SHEARON HARRIS NUCLEAR POWER PLANT
FAULT INVESTIGATION

Responses to Mr. W. R. Butler's
letter of 16 May, 1975

FIGURE 1 SCHEMATIC EPISODE - TEMPERATURE HISTORY CHART

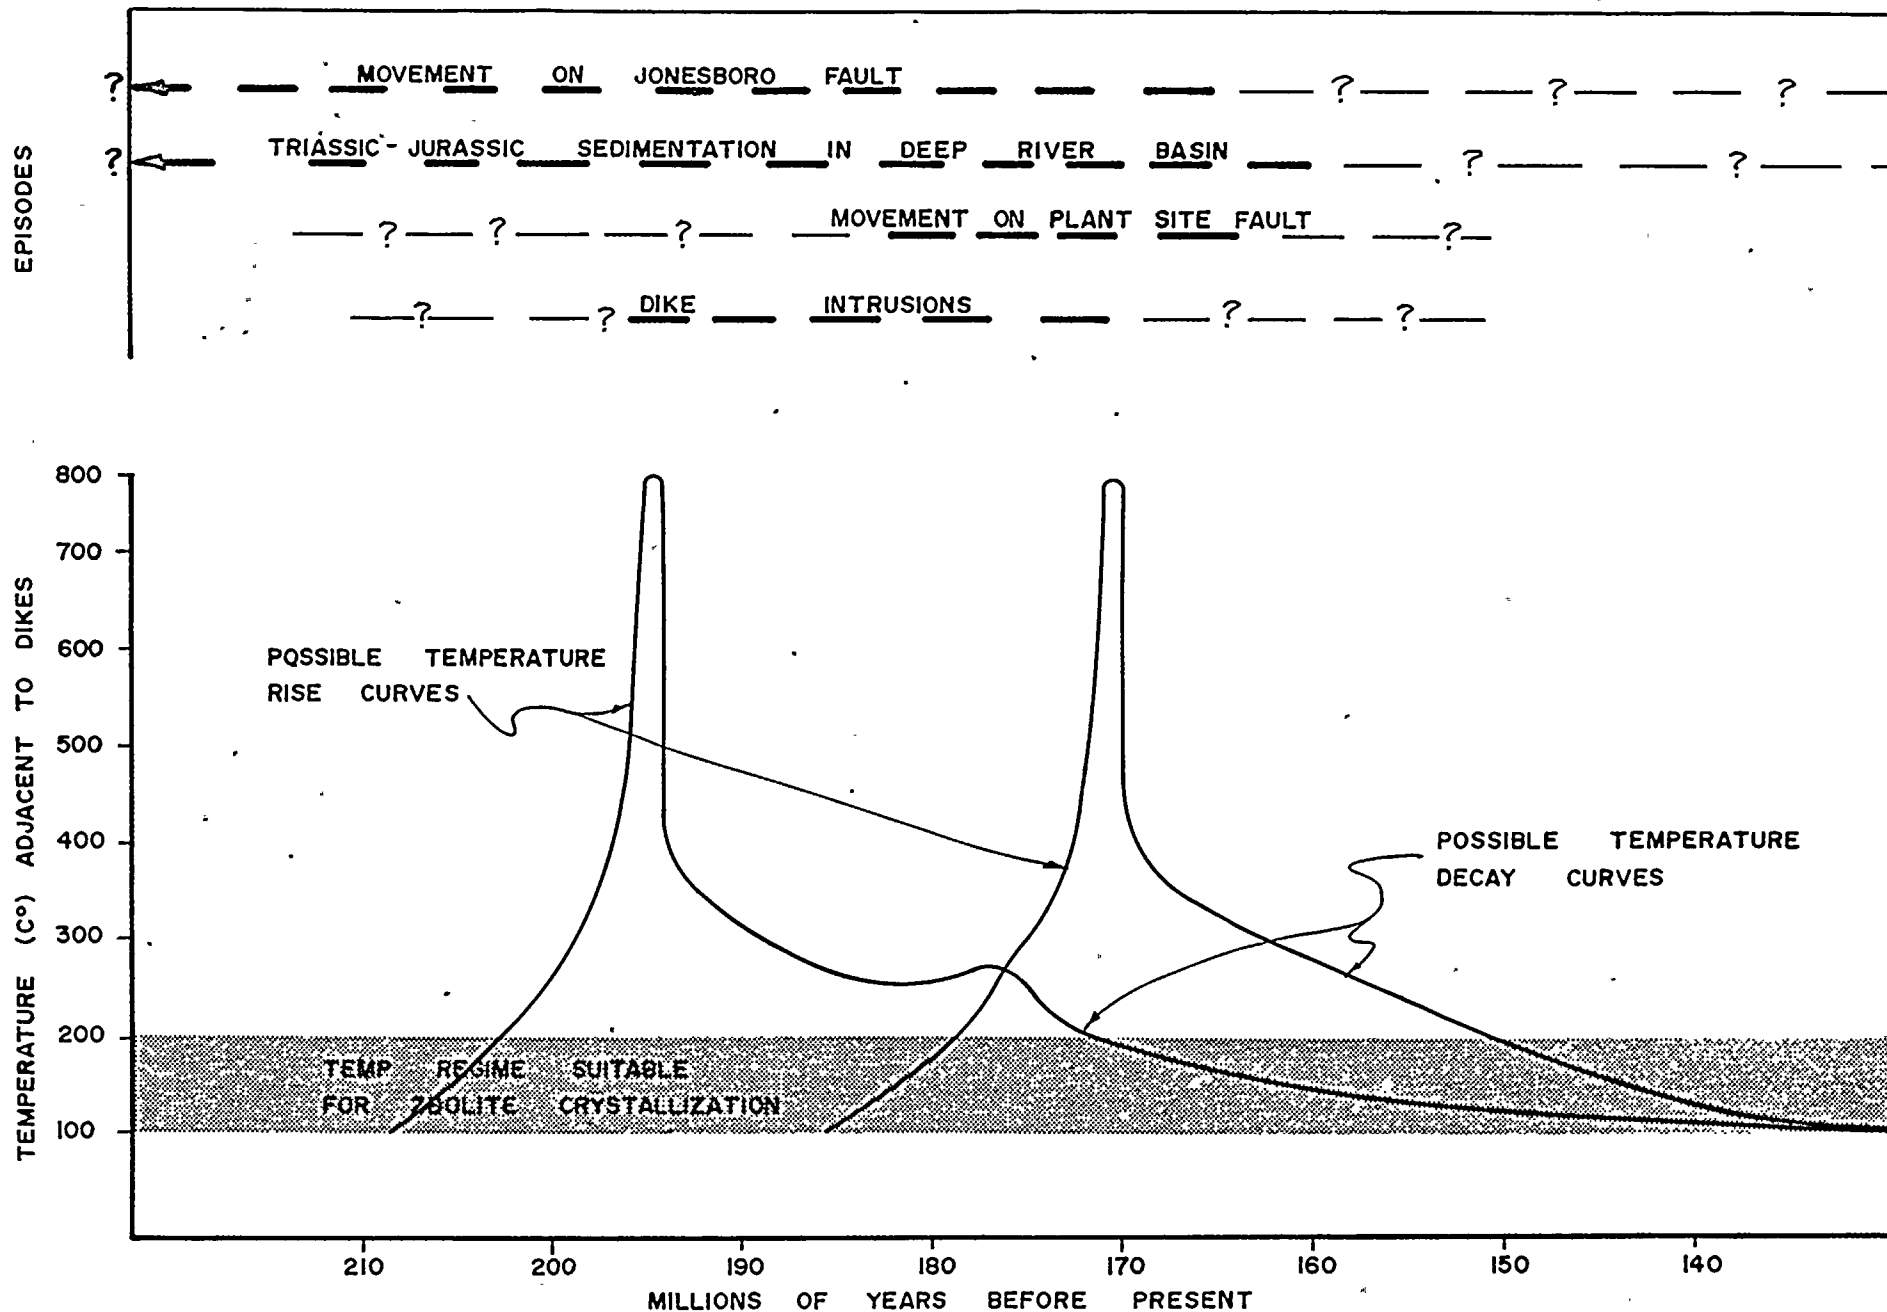
Discuss evidence for an episode of regional metamorphism other than paleomagnetism and a general discussion of burial metamorphism, as well as the need for such an episode in determining the capability of the site fault. This discussion should include considerations of the temperature - pressure - phase relationships of the zeolite minerals examined.

In the context of the present Fault Investigation Report, it is intended to be understood that "burial" metamorphism requires only that depth of cover which is necessary to form sufficient thermal insulation to sustain temperatures of 100° C plus for geological periods of time on an areal basis. The recent suggestion by Dallmeyer (1975) that some rock units earlier considered to be Triassic may in fact be Jurassic is consistent with the interpretation that the low - grade metamorphic event described in the Fault Investigation Report is of Jurassic age. A schematic chart of possible episode - temperature correlations is enclosed as Figure 1.

Figure 2
SECTION THROUGH POSITIONS
1-2-3-4

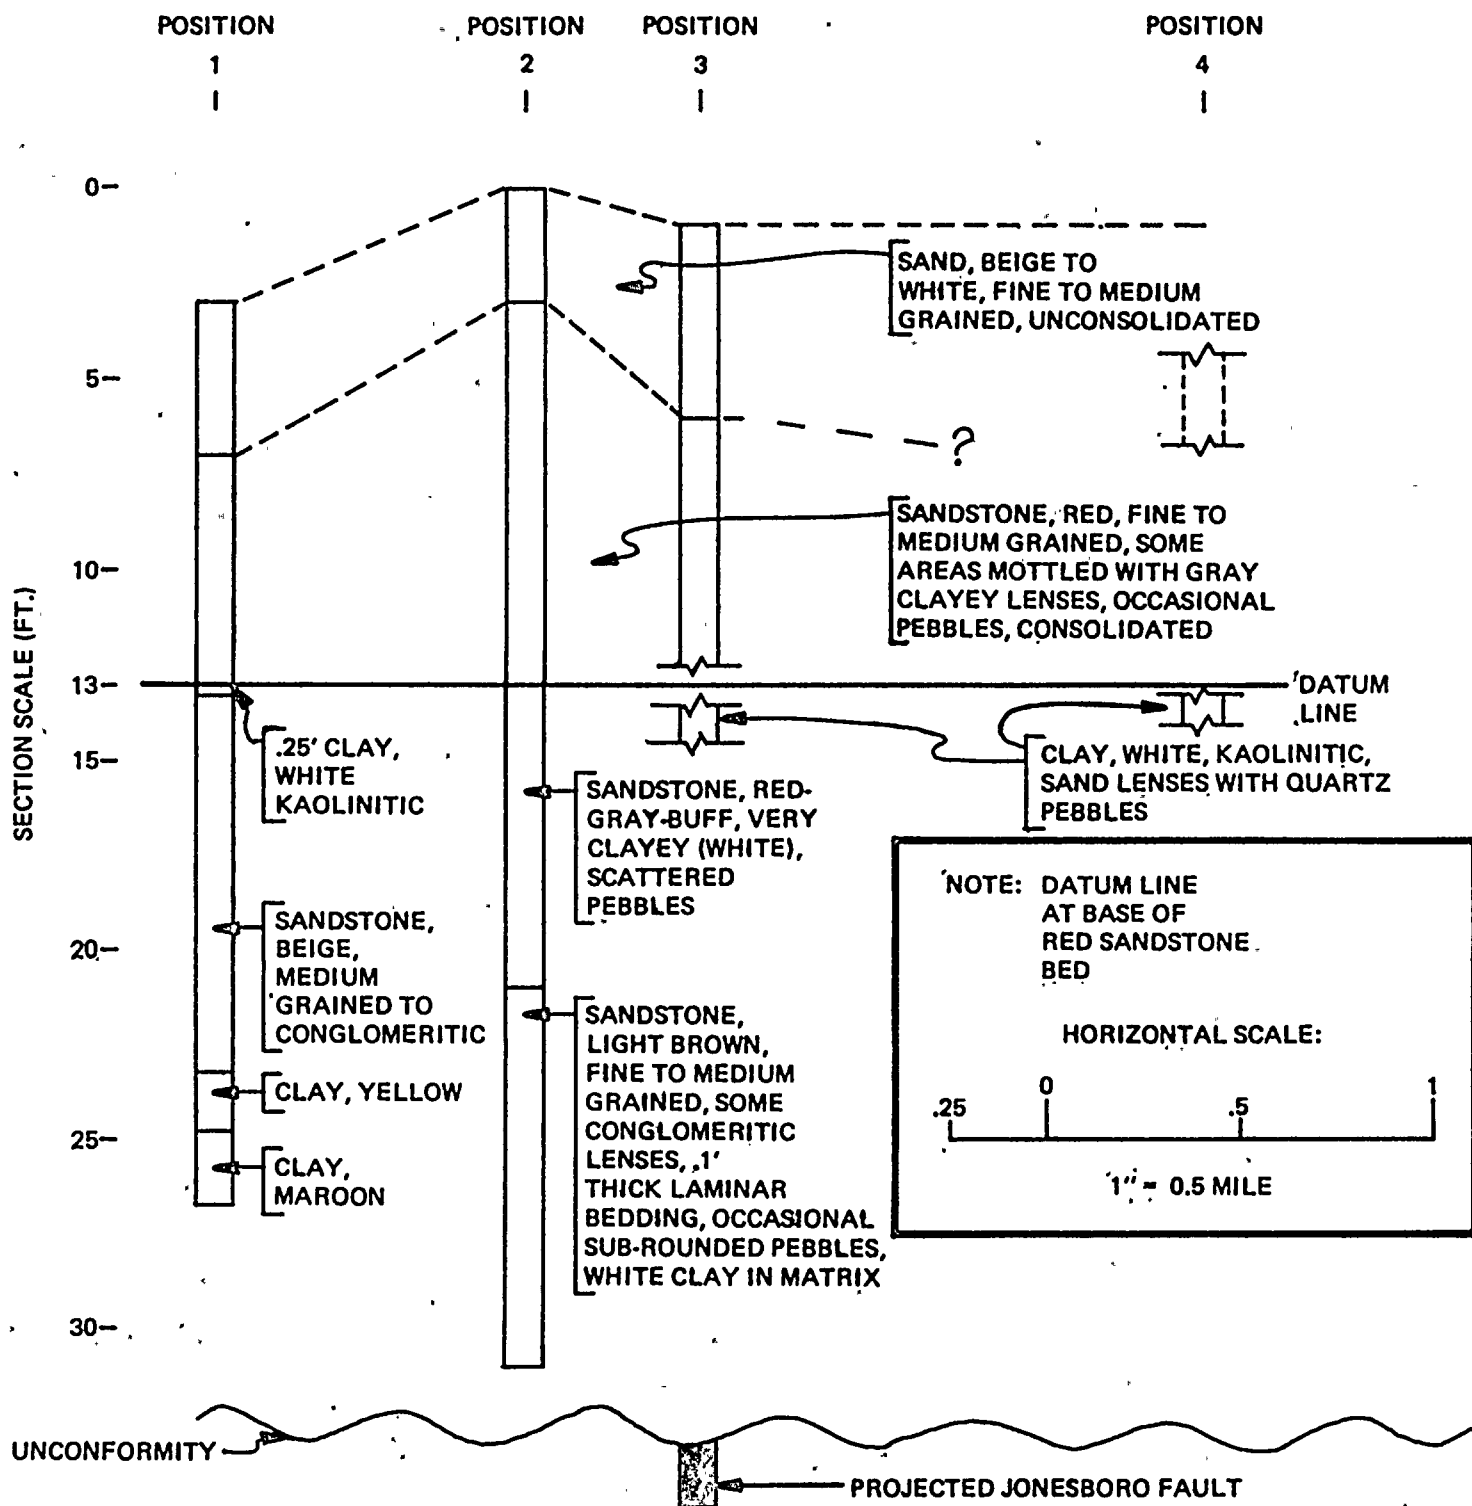
Provide further documentation of the lack of offset of Cretaceous (?) rock by the Jonesboro Fault. Include items such as maps, photos, etc.

- 1) Horizontal bedding was observed in the Cretaceous beds where they are well exposed, and good correlations of these beds can be carried across the projected location of the fault with no apparent offset.
- 2) No jointing or any other evidence of deformational strain is present in the observed exposures of the Cretaceous deposits. Particularly significant is the lack of strain in the exposure overlying the projected location of the fault (Position 3).
- 3) No apparent fault controlled drainage is exhibited in the development of the dendritic stream pattern throughout the area underlain by Cretaceous deposits.
- 4) The residual sandy soil, derived from the Cretaceous deposits, is the same and supports the same vegetation on either side of the projected location of the fault.

FIGURE 3

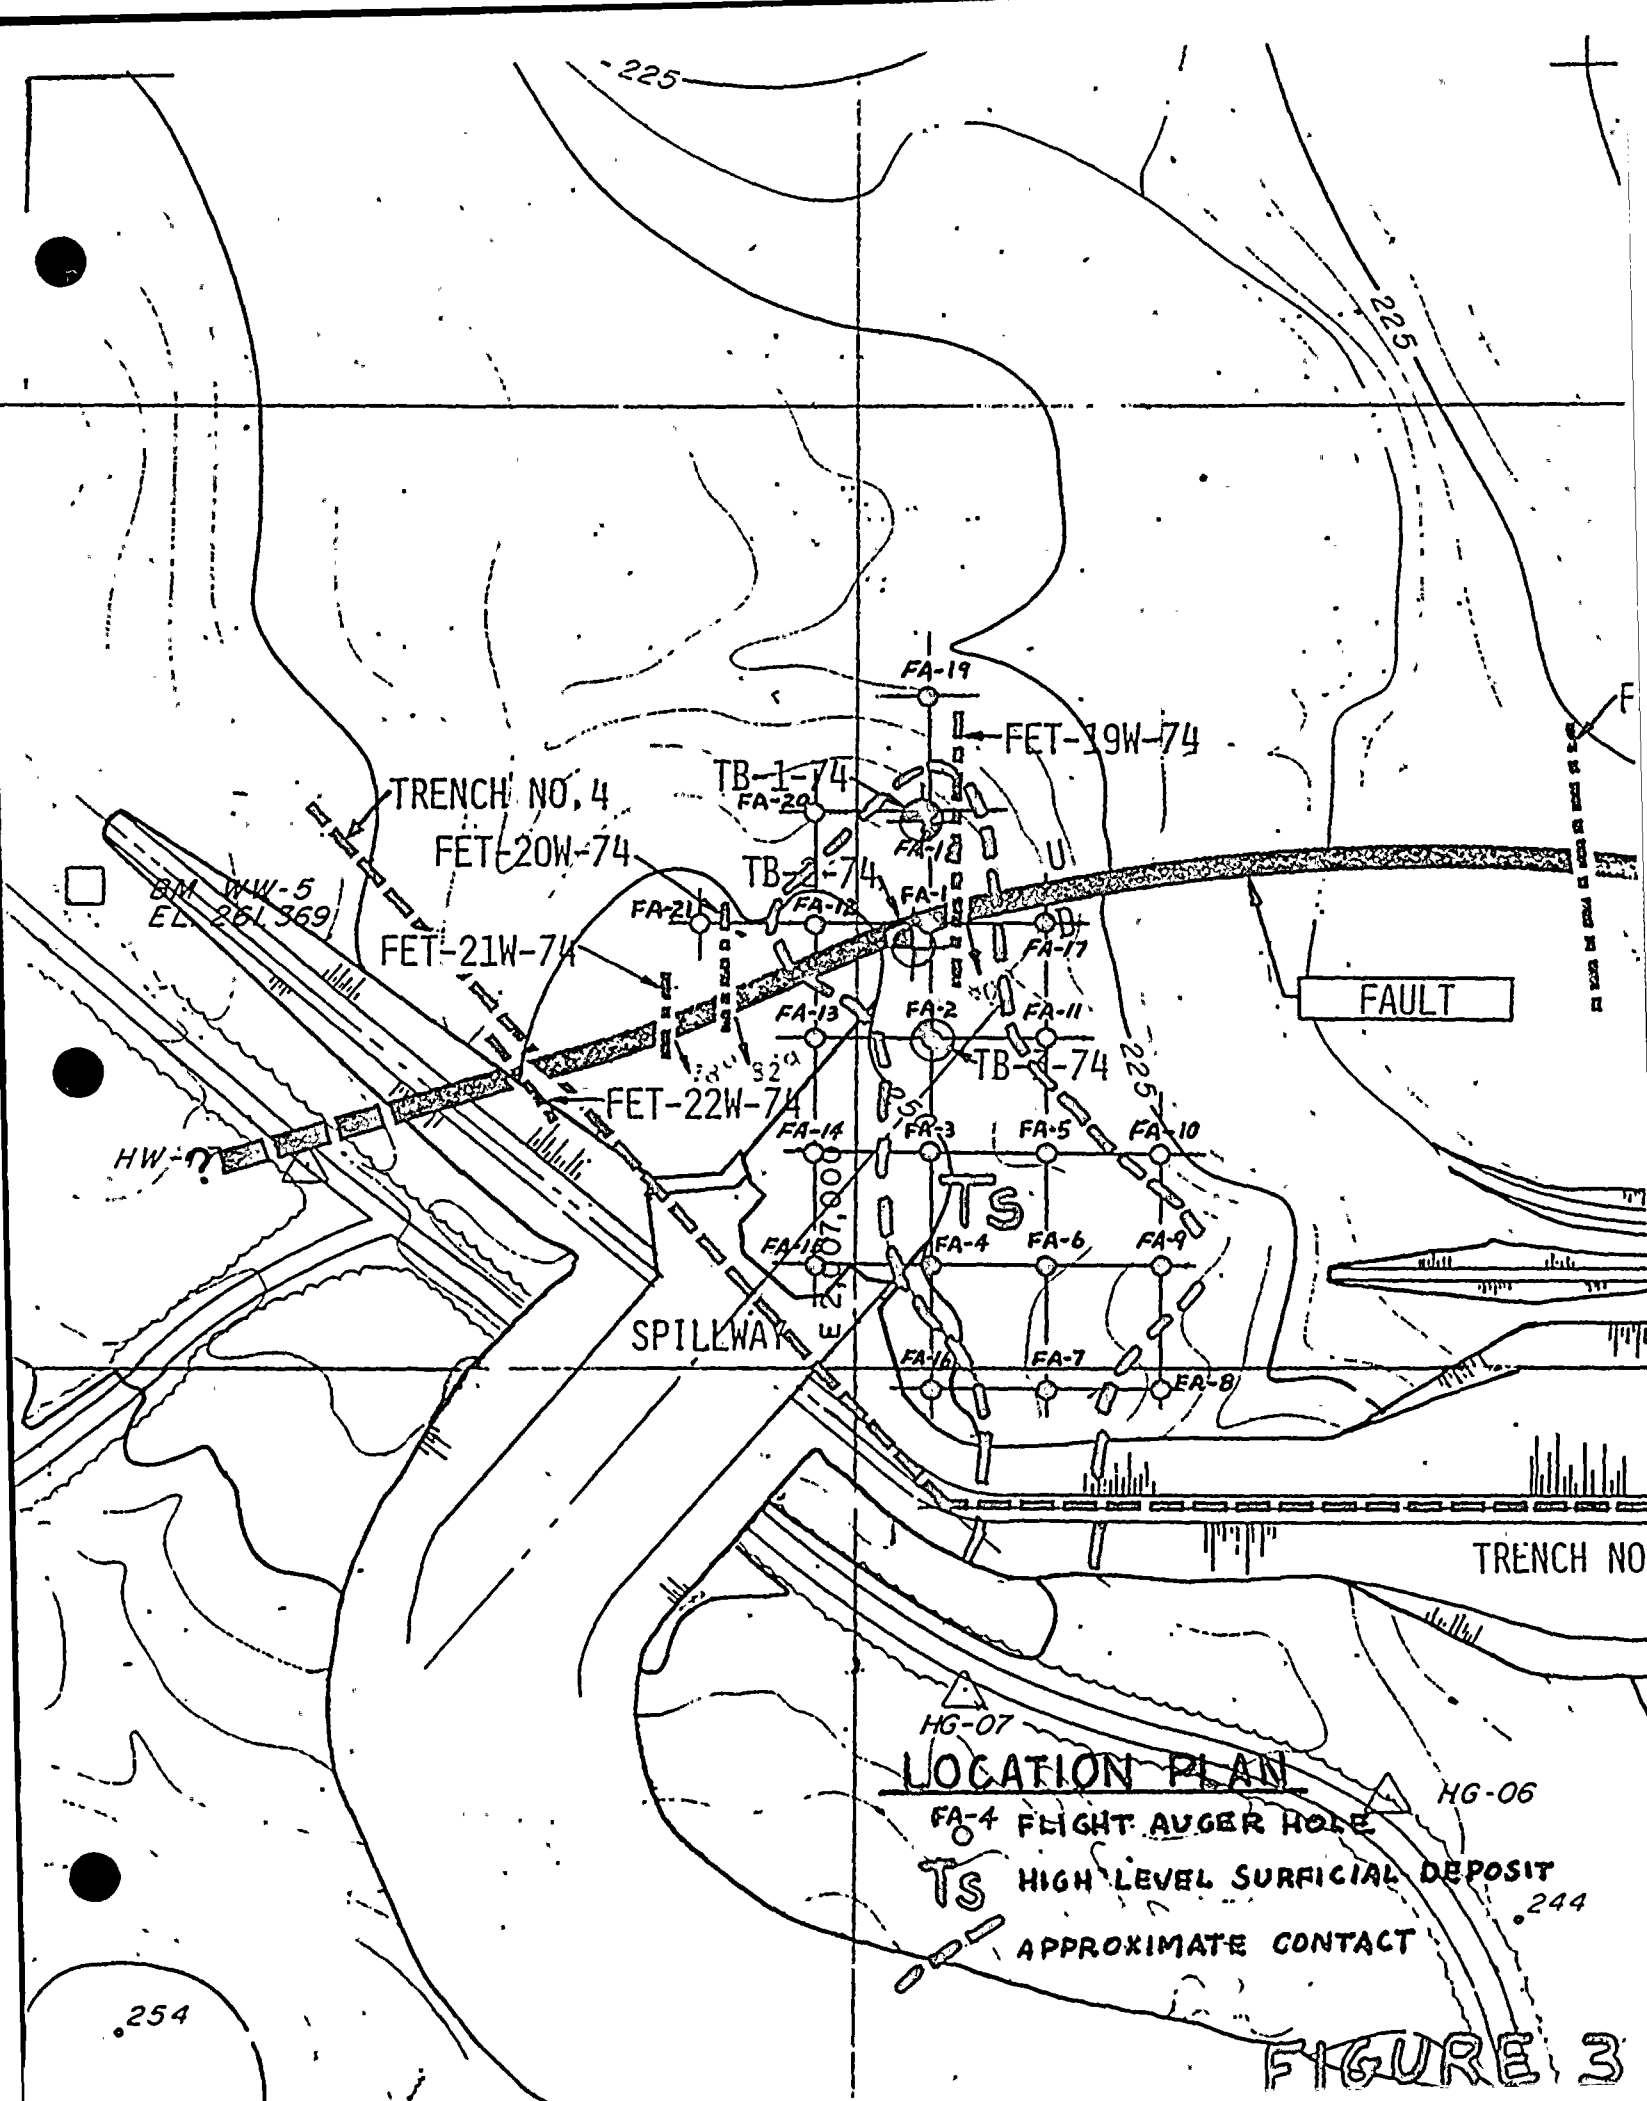
Provide all evidence available to support your statement that the site fault is overlain by undisturbed Pliocene strata.

Of the 21 borings, seven encountered an apparent basal layer containing rounded quartz pebbles immediately overlying bedrock and three encountered traces of clean uniform sand. This information, combined with the relatively deeper soil depths at these locations was judged to indicate continuations of the same High Level Surficial Deposit exposed in Trench FET-19W and limits were drawn accordingly (see accompanying location plan, Figure 3.)
